Product/Process Change Notice (PCN)

File Number #: ConUSB_20150605
 Product Affected: 614004135023, 6140041350231
 PCN Date: June 19th, 2015
 Effective Date: September 18th, 2015
 Contact: Product Management
 Tel: +49 7942 945-5001
 Fax: +49 7942 945-5179
 E-mail: PCN.eican@we-online.de

<u>Old Design</u>	<u>New Design</u>

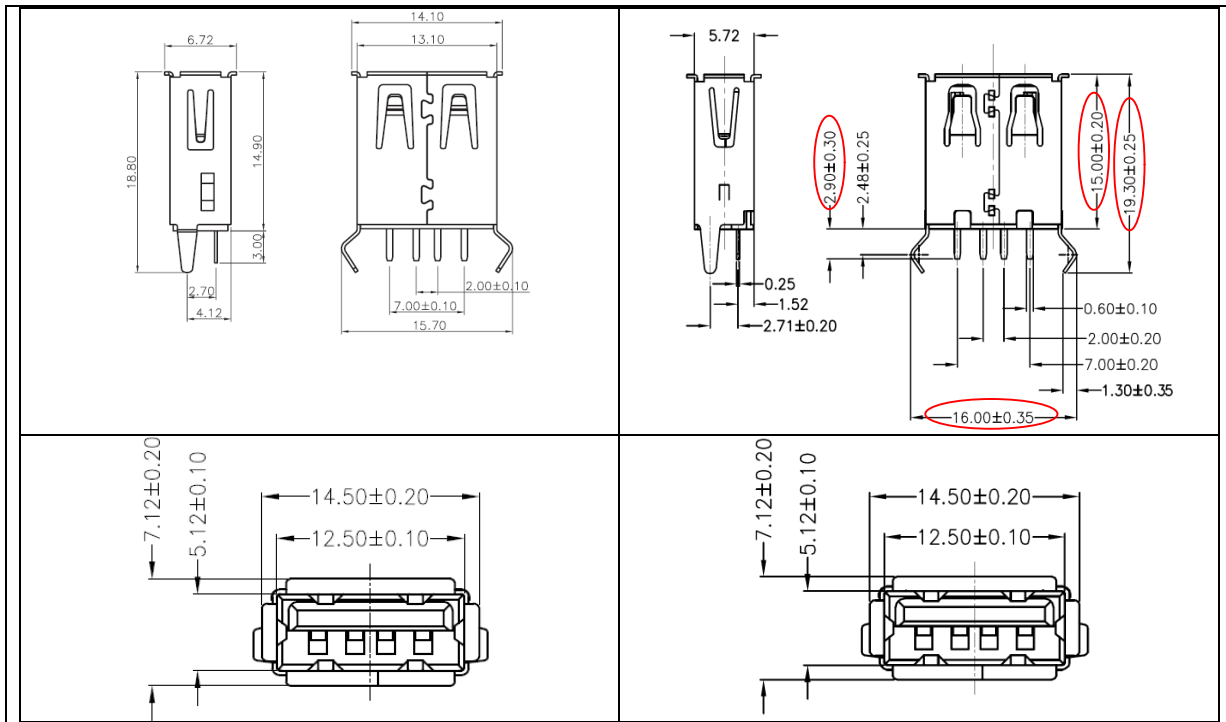
A fully automatized process will be implemented and CCD inspection controls will be added. The design changes are summarized below and marked in red:
